CITY OF PORTLAND

October 27, 1993

RE: 8 Chester Street

Re: Application By Arthur and Kathryn Ellis for Permir to Build Porch at 8 Chester Street

SKETCH FLAN

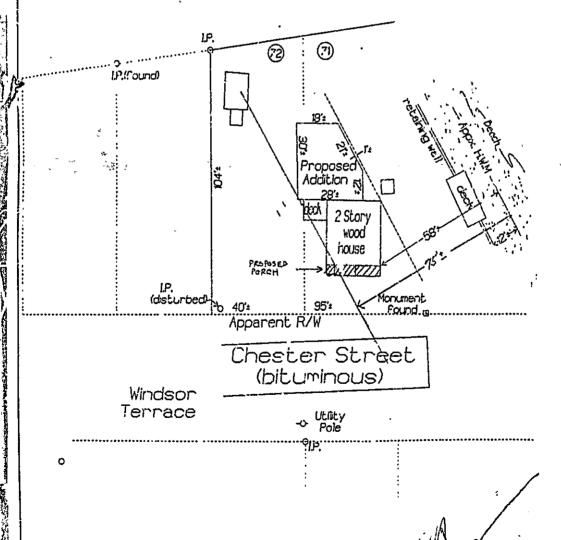
According to the site plan enclosed with this letter, the existing front porch is set-tack slightly more than 15 feet from the sideline of the Chester Street right-of-way. The proposed porch would be the same distance from the right of way. Therefore, the proposed porch would satisfy the front setback set forth in the 1957 ordinance.

In addition, the porch would have a side set-back vastly exceeding 7 feet on both sides. Accordingly, the proposed porch would also satisfy the 1957 side set-setbacks.
